# Access Compliance Report

## Public Rights-of-Way

Intersection ID: N/A	Main Street: W W T HARRIS BV	Cross Street: N/A	Location: NE
ADA ID: A836F6A8034A	Ramp Type: Directional1	Initial Pass/Fail: Fail	Overall Compliance: No
		Severity Score: 52.5	
Codes/Mitigation Info/Possible Solution		Field Measurements/Component Compliance

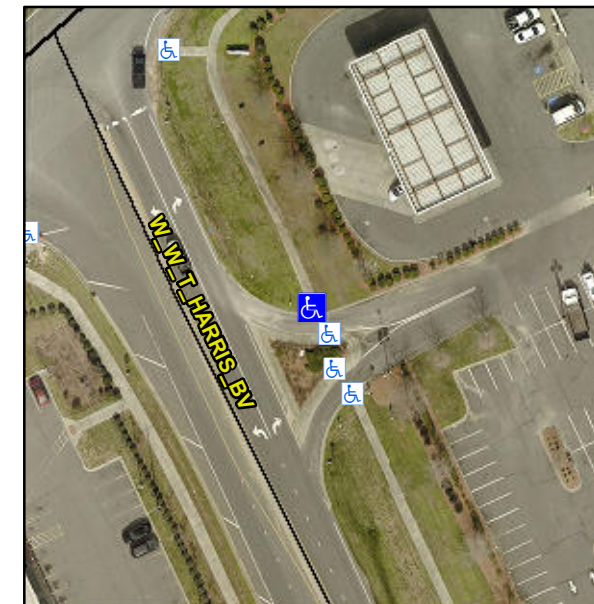
**R304.2.2, R304.5.3, R302.7**

Compliance	Description	Data	Compliance	Description	Data
N/A	Ramp Length (in)	67.0	N/A	Grade Break?	N/A
Yes	Ramp Width (in)	68.0	N/A	Grade Break Slope (%)	0.0
No	Ramp Slope (%)	12.9	N/A	Grade Break XSlope (%)	0.0
No	Ramp XSlope (%)	6.0			
N/A	Flare Type LT	N/A	N/A	Flare Type RT	N/A
N/A	Flare Slope LT (%)	N/A	N/A	Flare Slope RT (%)	0.0
N/A	Flare Traversable LT?	N/A	N/A	Flare Traversable RT?	N/A
N/A	Landing Length (in)	0.0	N/A	DWS Provided?	N/A
N/A	Landing Width (in)	0.0	N/A	DWS Contrast?	N/A
N/A	Landing Slope (%)	0.0	N/A	DWS Length (in)	N/A
N/A	Landing X Slope (%)	0.0	N/A	DWS Full Width?	N/A
N/A	Landing Curb? (Y/N)	N/A	N/A	DWS Offset LT (in)	N/A
N/A	Shared Landing?	N/A	N/A	DWS Offset RT (in)	N/A
N/A	Gutter Ponding?	0.0	N/A	Gutter Slope (%)	N/A
N/A	Gutter Lip Ht (in)	0.0	N/A	Gutter X Slope (%)	N/A
N/A	Painted X Walk1?	No		Road Slope (%)	0.8
	X Walk 1 Direction	To S		Road X Slope (%)	4.8
	X Walk 1 Width (in)	N/A		Clear Space?	N/A

X Walk 1 Slope (%)	0.8	N/A	Clear Space to XWalk (in)	N/A
	X Walk 1 X Slope (%)	4.8	N/A	Storm Grate/Utility Hazard?	N/A
N/A	Ramp inside XWalk1?	N/A		Storm Grate/Utility Type	
N/A	Any Obstructions?	N/A			N/A
	Obstruction Type		No	Surface Condition? (G/P)	Poor
			N/A	Curb Slope (%)	2.1

**Remove & Replace Entire Ramp.**
